**Homestead High School Expansion/Renovation Project
Phase 2B - Gymnasium and Auditorium Additions - General Construction
12.11.20
Addendum No. 3**

Questions and Front End Clarifications - Pre-Bid Meeting - CSO Architects Addendum No. 3

The following information by issuance as Addendum 03 shall be included and become part of the Bidding Documents and therefore part of the Construction Documents.

DRAWING NUMBER
TR317B

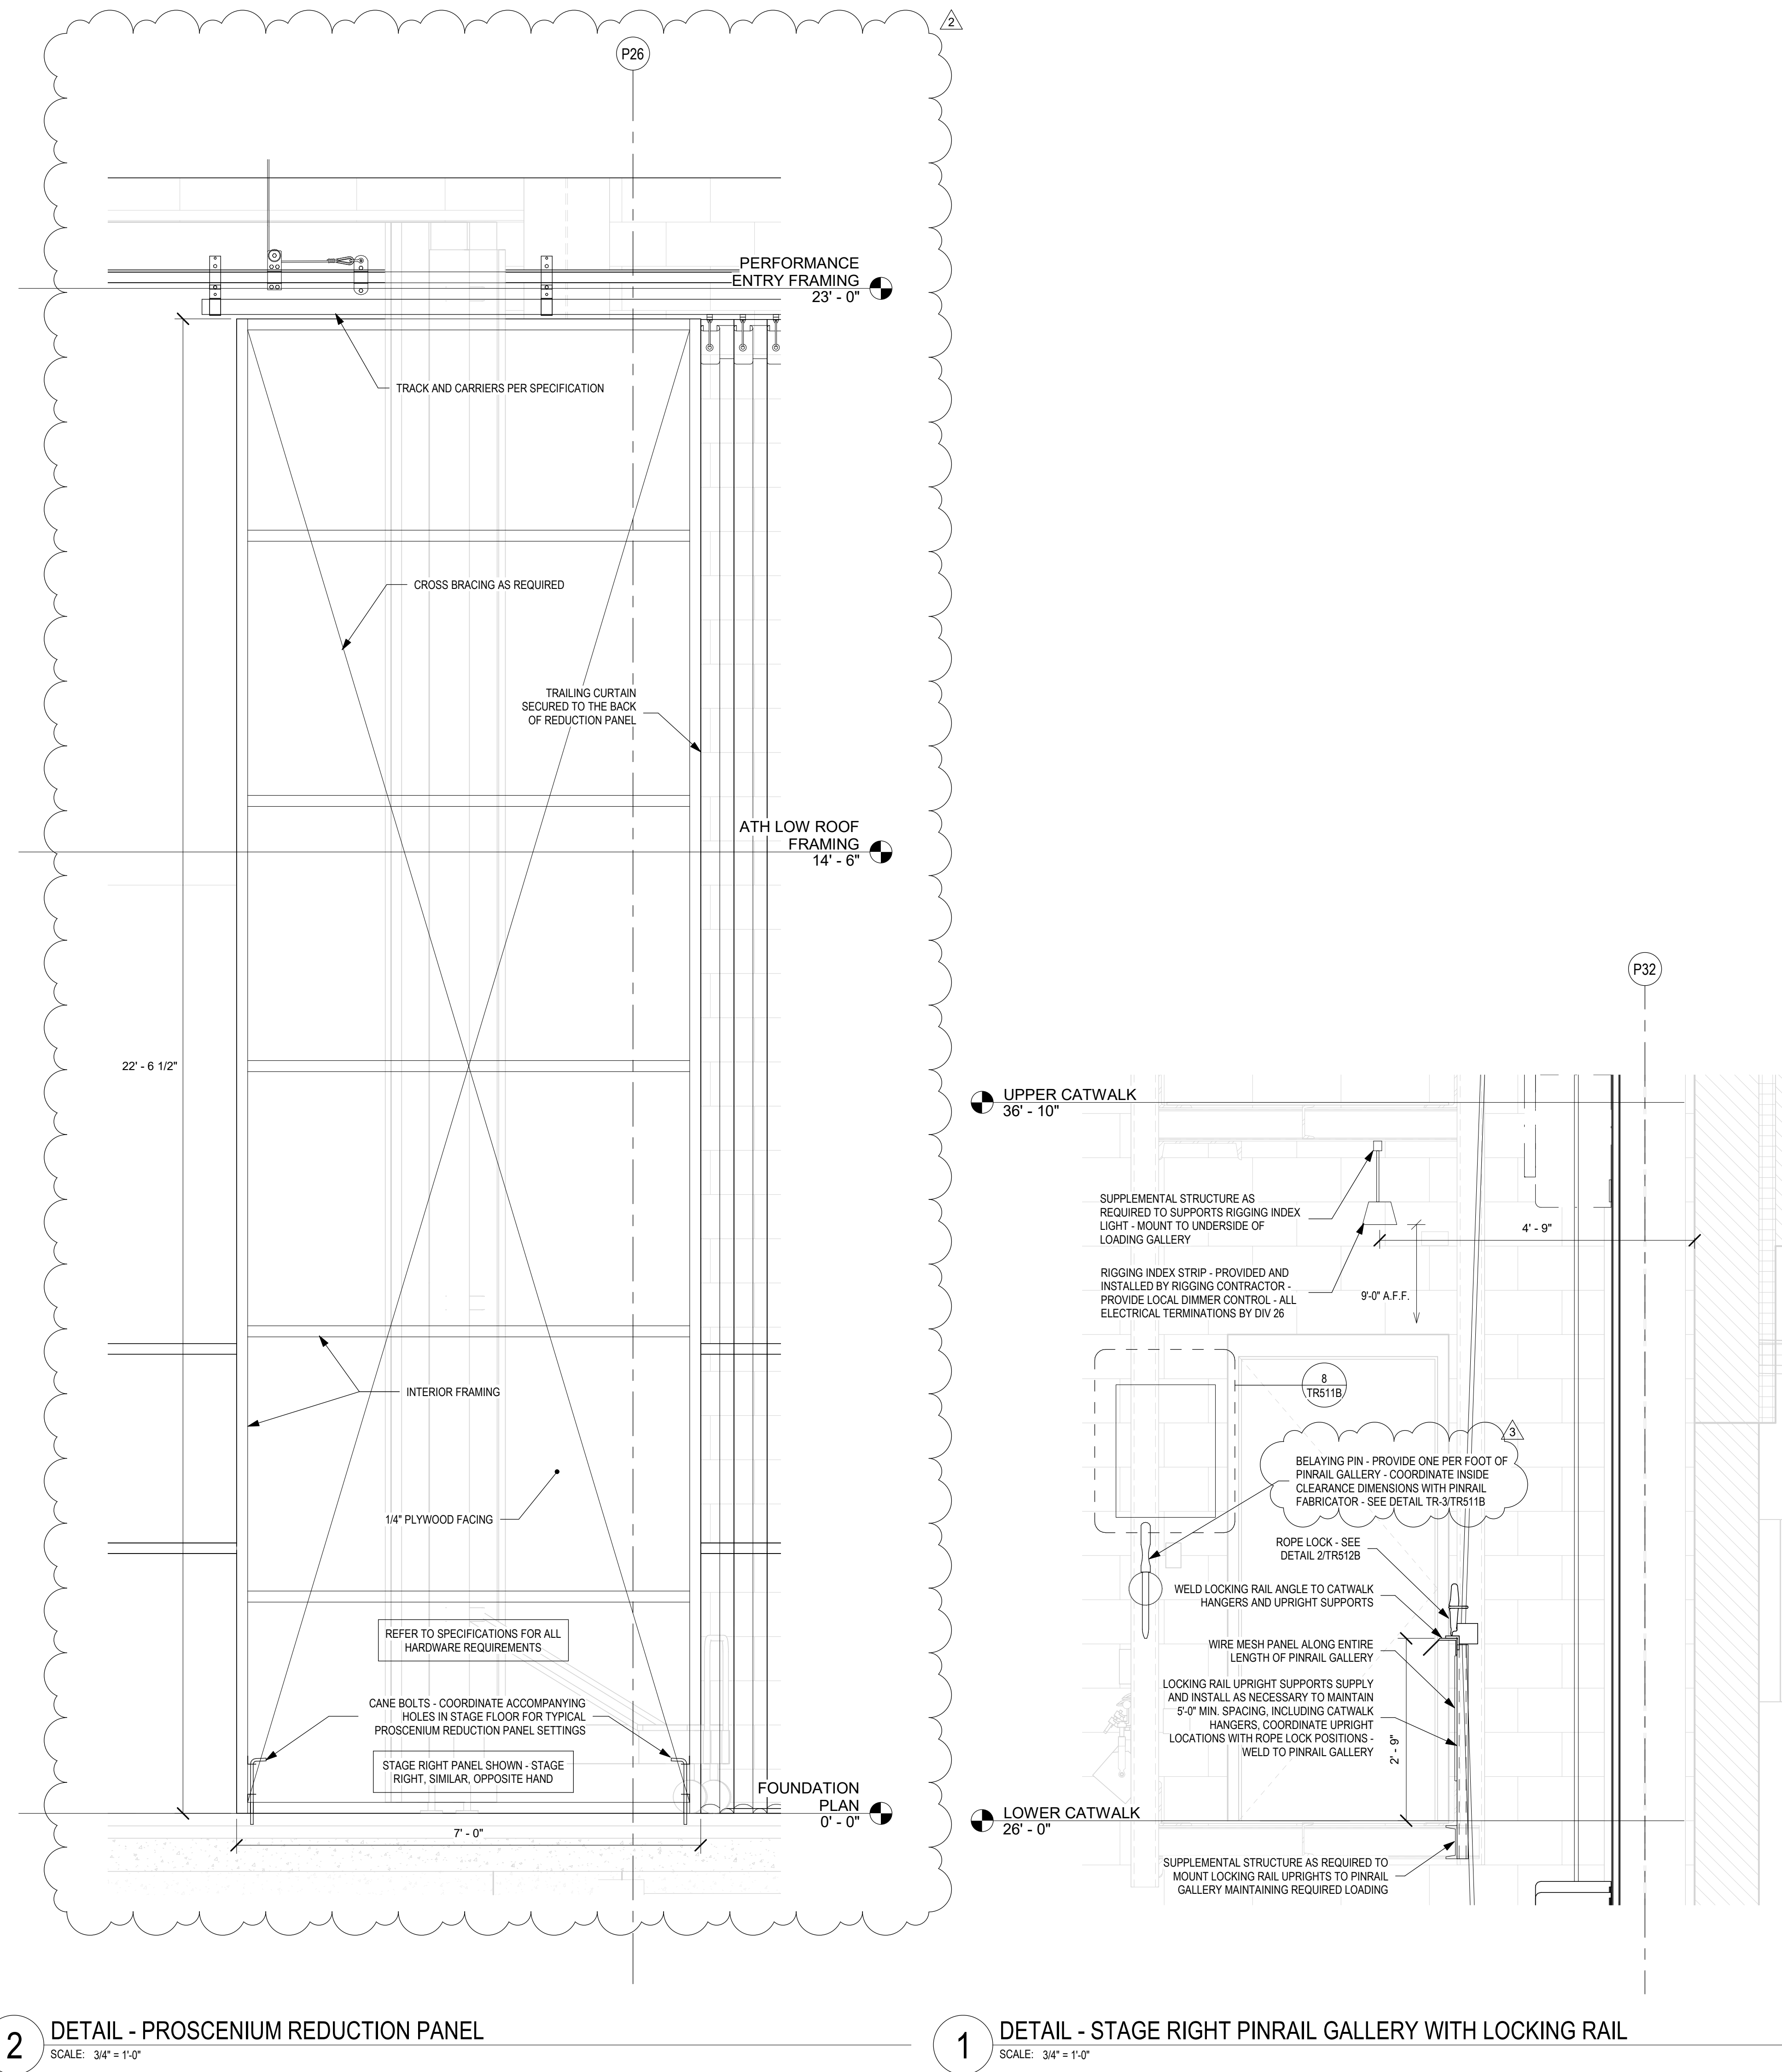
23. Drawing TR317B shows a pantograph for cable handling for the Orchestra Ceiling Enclosure sets. This adds significant weight to the line set. Will cable reels be acceptable for cable handling? **CSO/Schuler This method is acceptable, however bidder must confirm reels do not interfere, conflict, or hinder operation of any and all other adjacent systems and equipment.**

10 TICKET BOOTH - WEST
A310-2 SCALE: 1/8" = 1'-0"

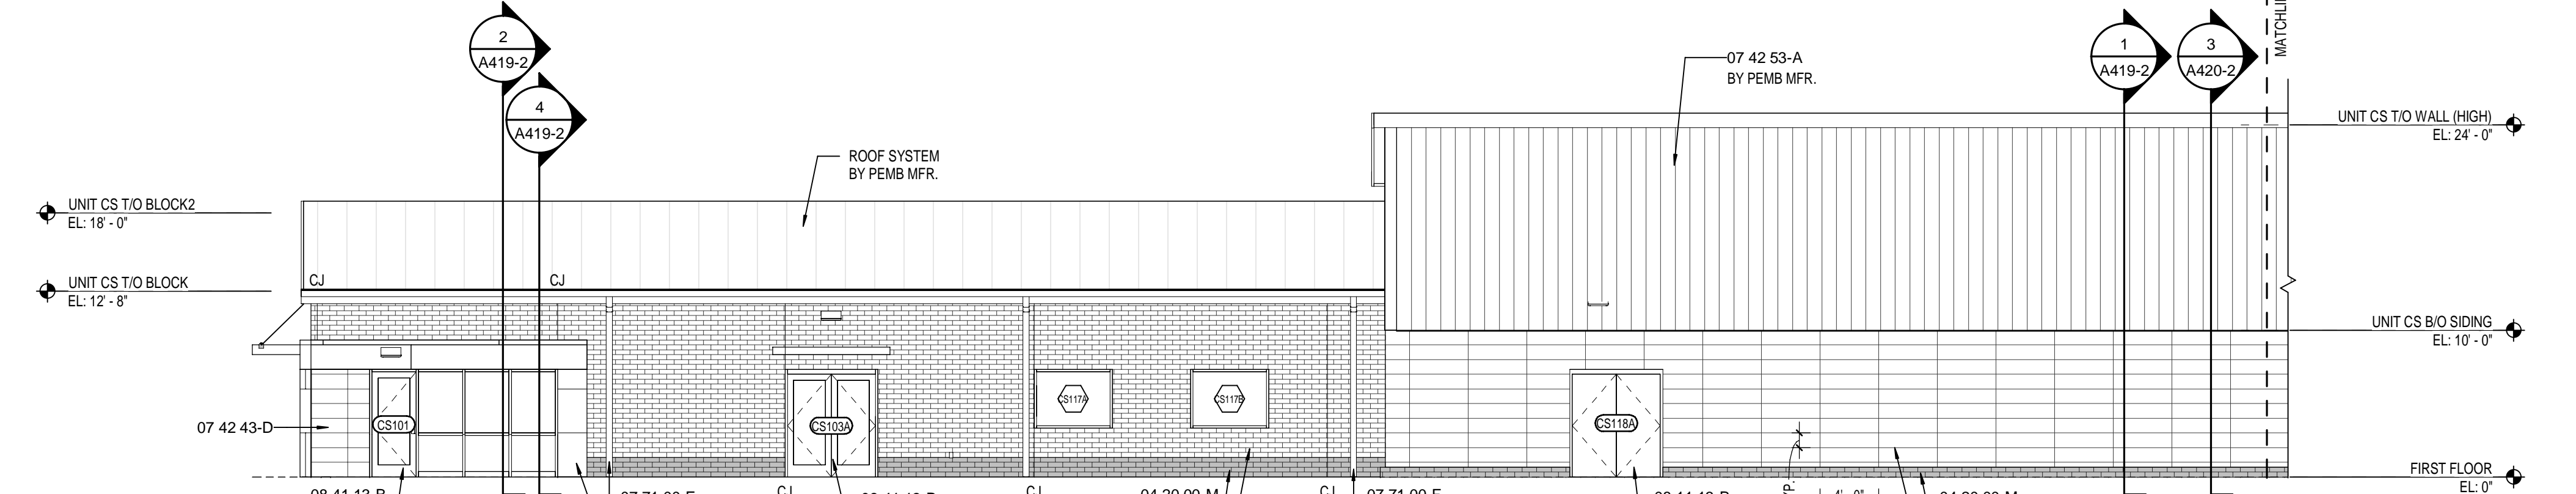
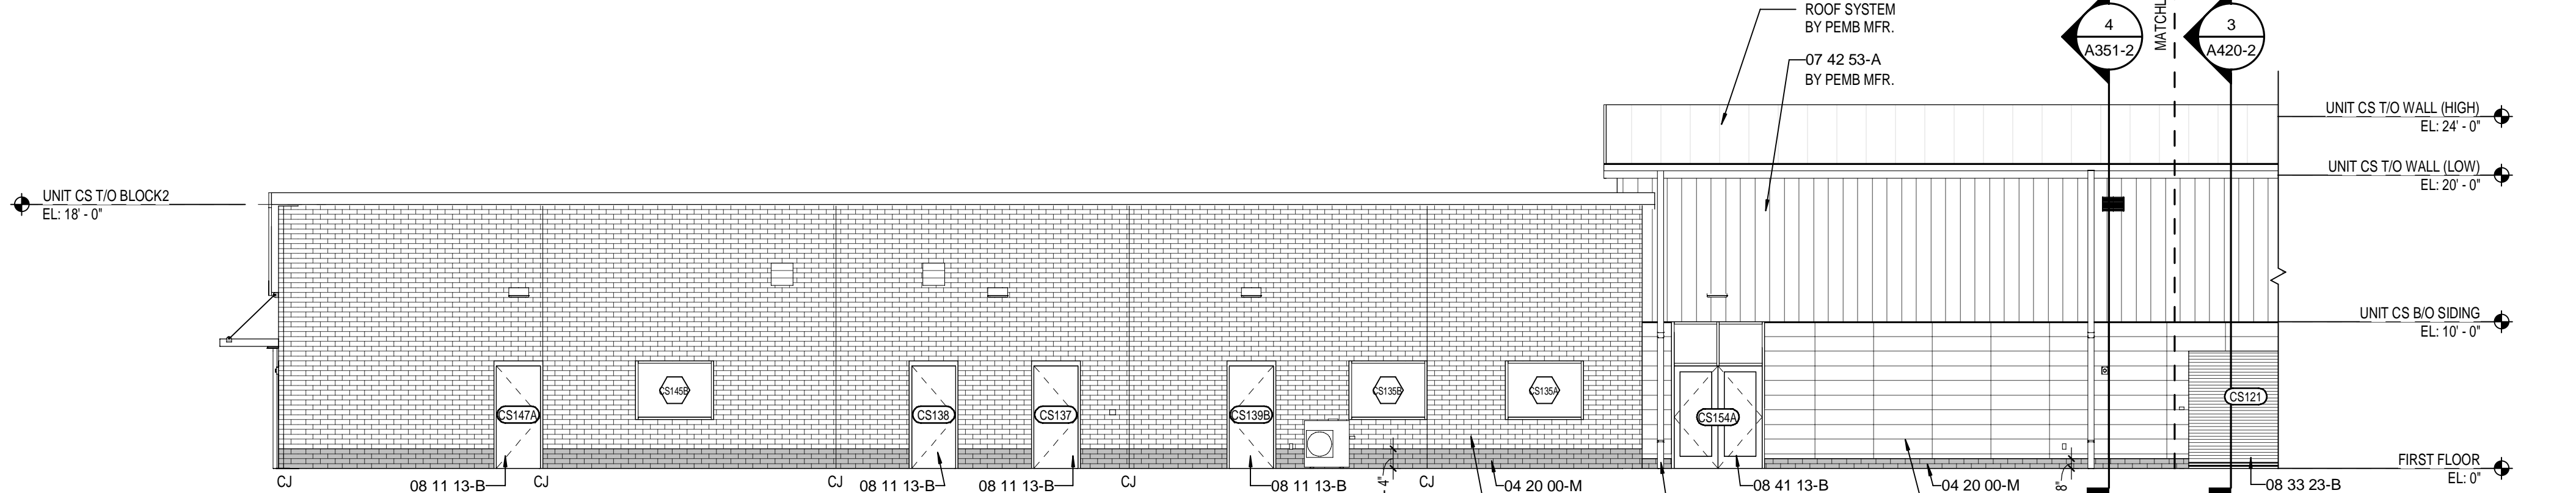
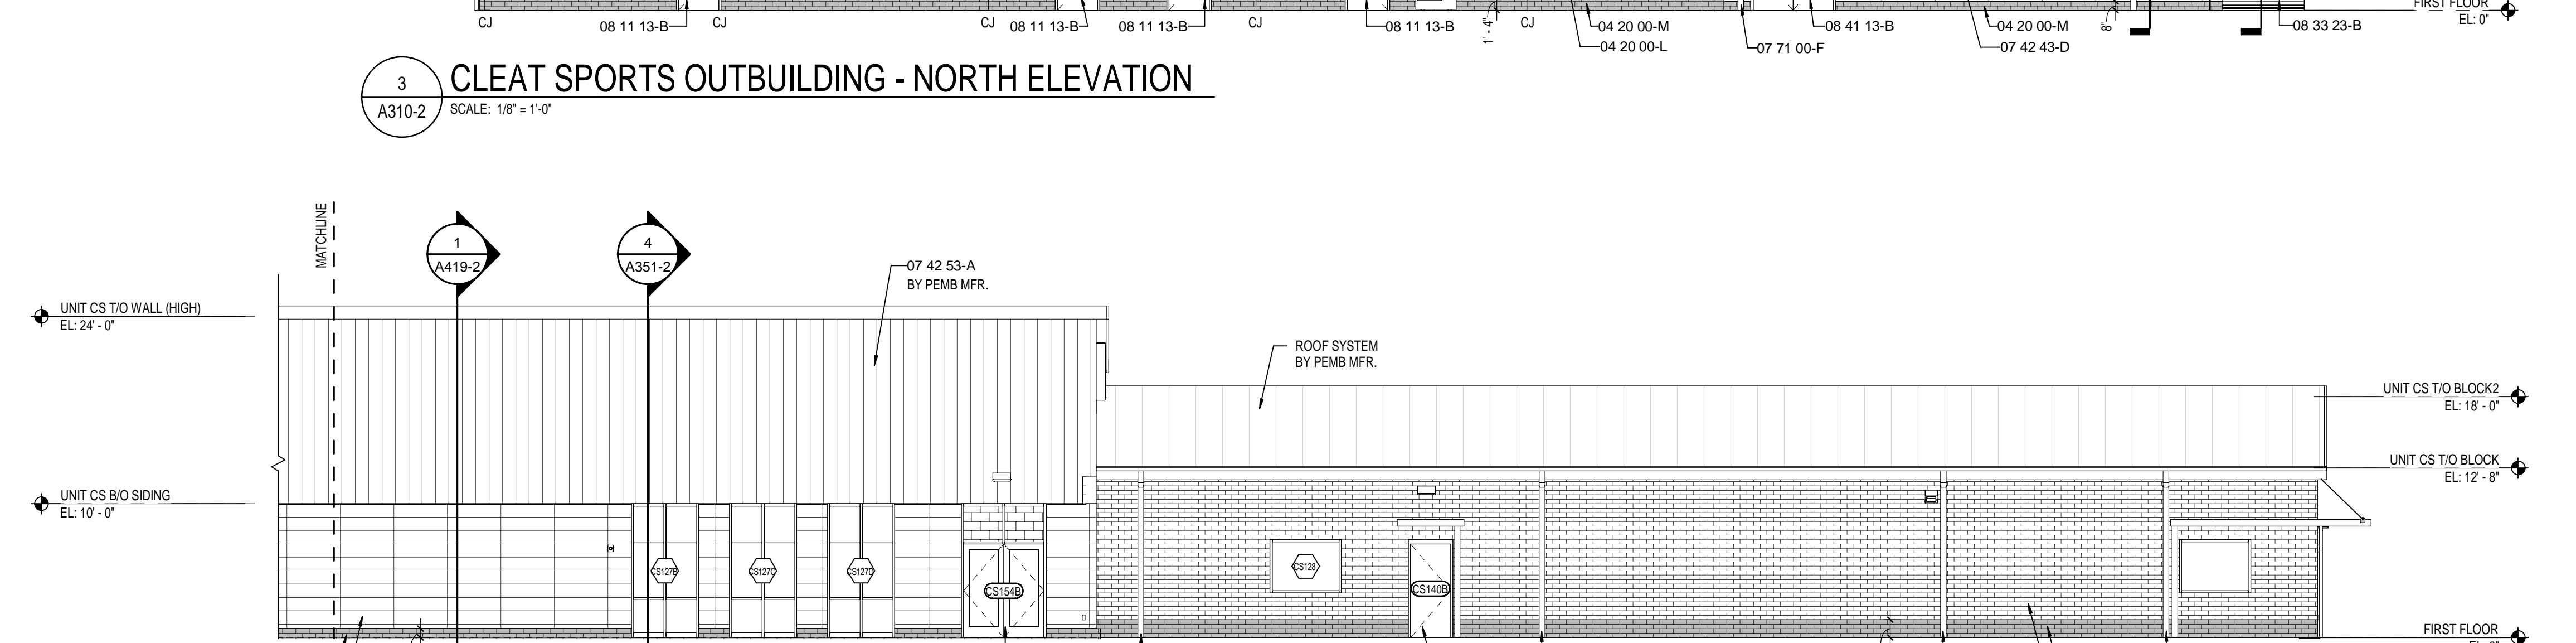
- Item: 3.03**
Location: Ticket Booths
Description: Ticket Booths to be wood framed in lieu of metal stud. BP-19 to furnish material and labor to frame as part of rough framing package.

- A. 1/A201CS-2: Add door CS119B to Laundry Room CS119.
- B. 5/A201CS-2: Ticket booth wall constructed using 2x6 wood stud framing in lieu of metal studs as previously shown. Revised sections and details #5, #7, #8, and #9.
